THREE MILE ISLAND NUCLEAR STATION, UNIT 1

AMENDMENT TO FACILITY OPERATING LICENSE

Amendment No. 10
License No. DPR-50

ATTACHMENT TO LICENSE AMENDMENT NO. 10

CONTROL ROD GROUP WITHDRAWAL
LIMITS FOR 4 PUMP OPERATION UNIT

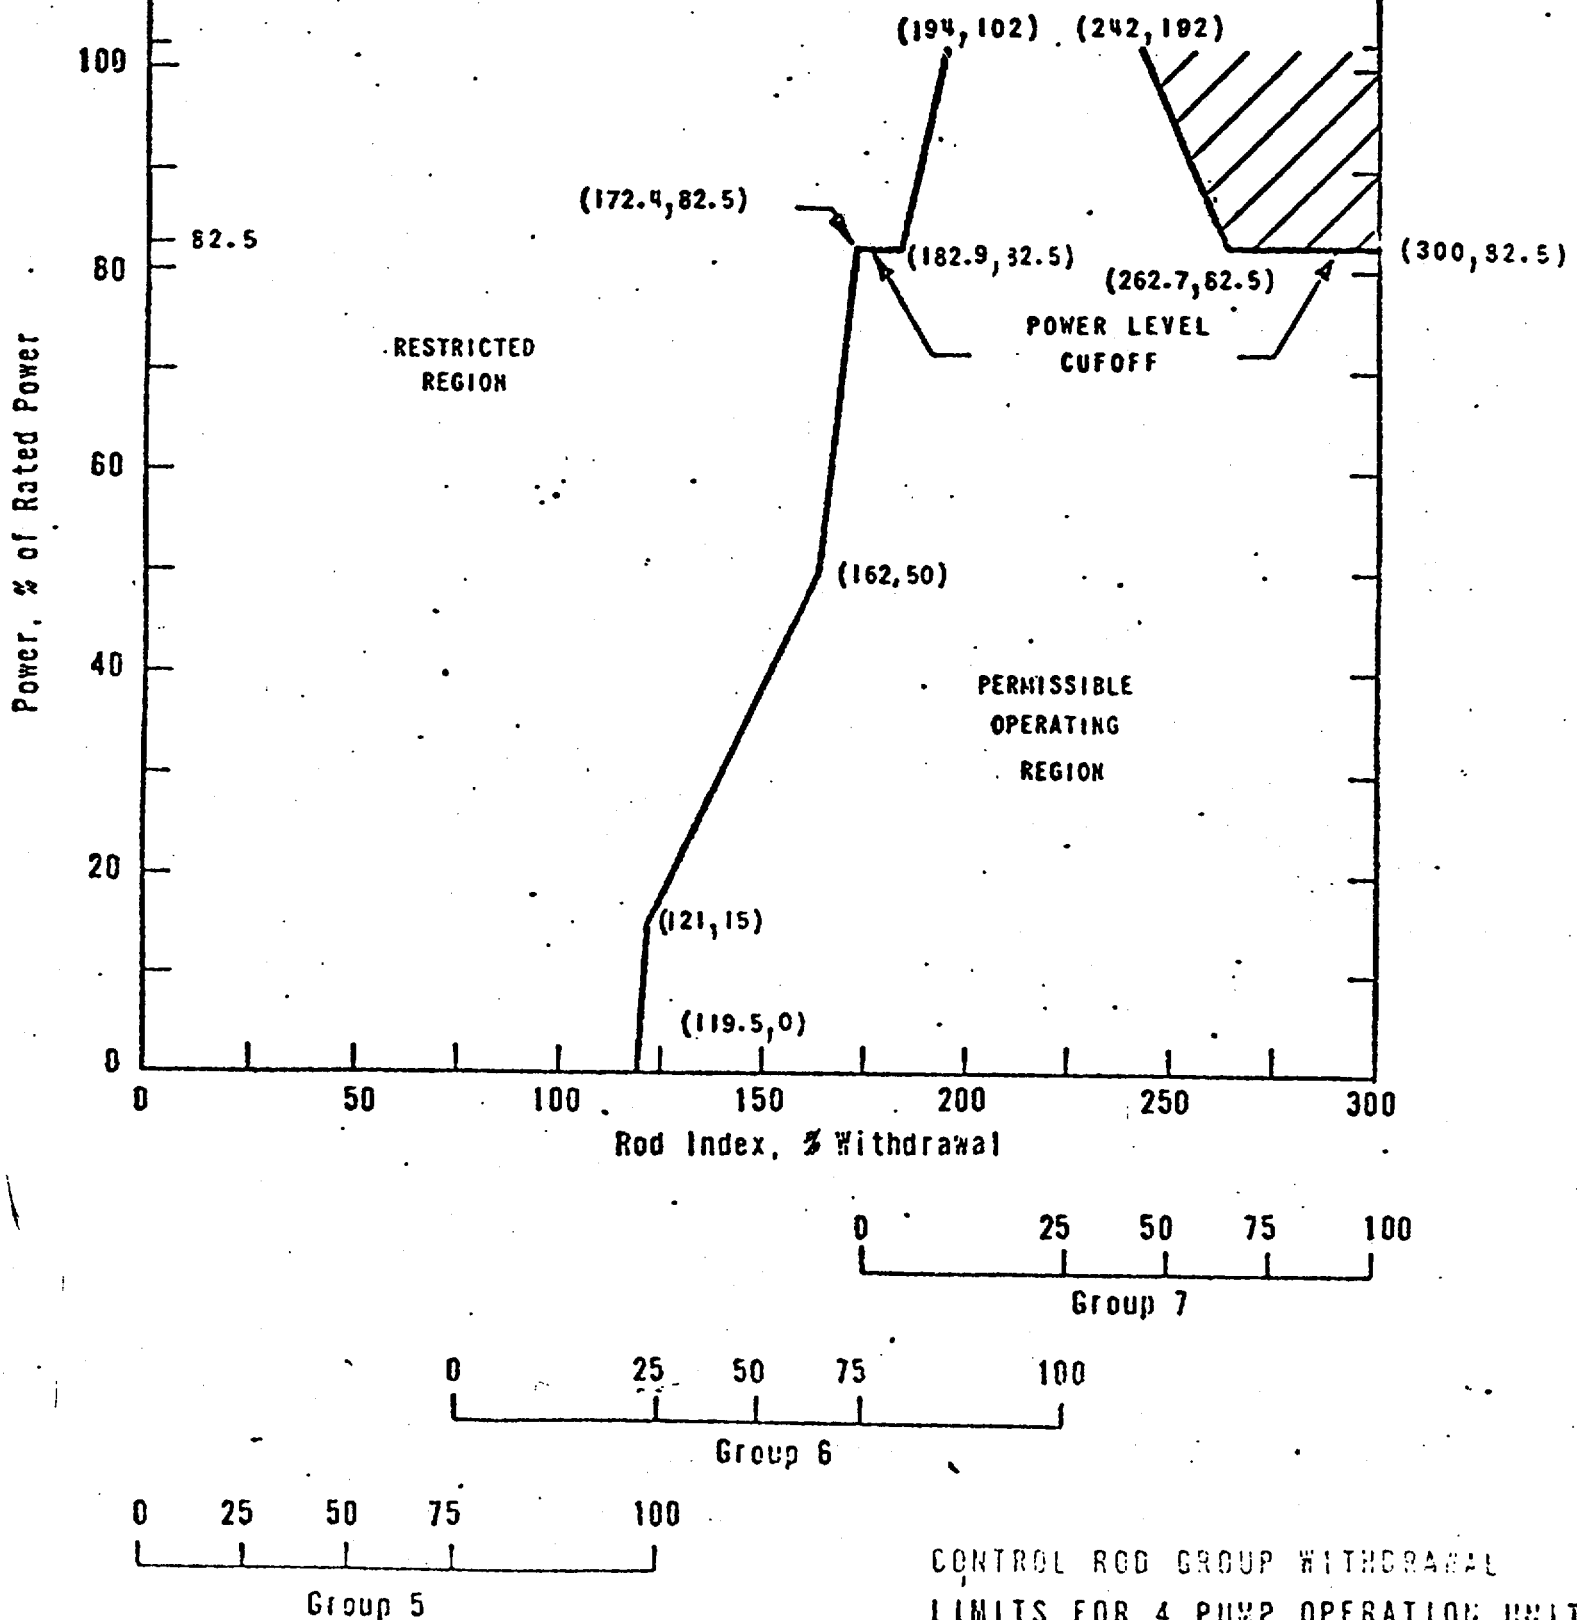
1. Rod index is the percentage sum of the withdrawal of the operating groups.
2. The additional restrictions on withdrawal (hashed areas) are in effect after the control rod interchange. The restrictions on withdrawal are further modified after 440 \pm 10 full power days of operation (See Figure 3.5-2C)
